Access Compliance Report

Public Rights-of-Way

(Curb Ramps)

Intersection ID: 42470	Main Street: DUKE_LANCASTER_DR	Cross Street: CASTLE_WATCH_AV	Location: SE
ADA ID: EE586372FBD1	Ramp Type: PerpDiag	Initial Pass/Fail: Fail	Overall Compliance: No
Severity Score: 22.5			
Codes/Mitigation Info/Possible Solution		Field Measurements/Component Compliance

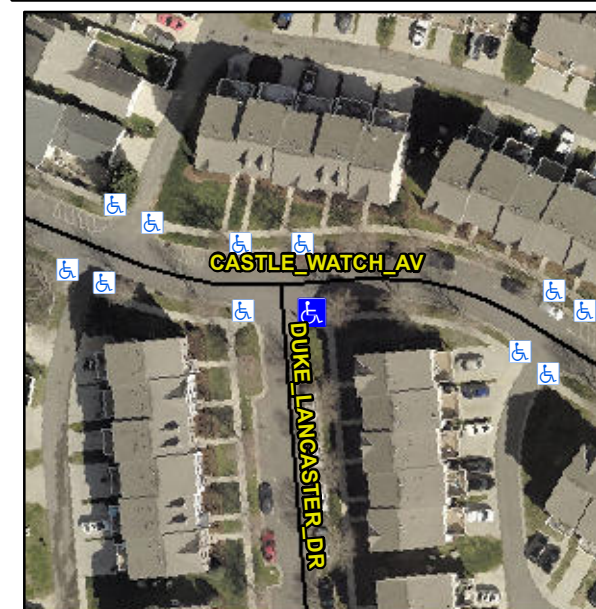
R304.5.1, R304.2.2, R304.5.3

Compliance	Description	Data	Compliance	Description	Data
N/A	Ramp Length (in)	119.0	No	Ramp Slope (%)	9.1
No	Ramp Width (in)	47.5	No	Ramp XSlope (%)	2.2
N/A	Flare Type LT	N/A	N/A	Flare Type RT	N/A
N/A	Flare Slope LT (%)	N/A	N/A	Flare Slope RT (%)	N/A
N/A	Flare Traversable LT?	N/A	N/A	Flare Traversable RT?	N/A
N/A	Landing Length (in)	N/A	N/A	DWS Provided?	N/A
N/A	Landing Width (in)	N/A	N/A	DWS Contrast?	N/A
N/A	Landing Slope (%)	N/A	N/A	DWS Length (in)	N/A
N/A	Landing X Slope (%)	N/A	N/A	DWS Full Width?	N/A
N/A	Landing Curb? (Y/N)	N/A	N/A	DWS Offset (in)	N/A
N/A	Shared Landing?	N/A			
N/A	Gutter Ponding?	N/A	N/A	Gutter Slope (%)	N/A
N/A	Gutter Lip Ht (in)	N/A	N/A	Gutter X Slope (%)	N/A
N/A	Painted X Walk1?	No	N/A	Painted X Walk2?	No
	X Walk 1 Direction	To N		X Walk 2 Direction	To W
N/A	X Walk 1 Width (in)	N/A	N/A	X Walk 2 Width (in)	N/A
	X Walk 1 Slope (%)	2.1		X Walk 2 Slope (%)	2.8
	X Walk 1 X Slope (%)	1.3		X Walk 2 X Slope (%)	2.4

Remove & Replace Curb Ramp With Two New Directional Ramps or Equivalent.
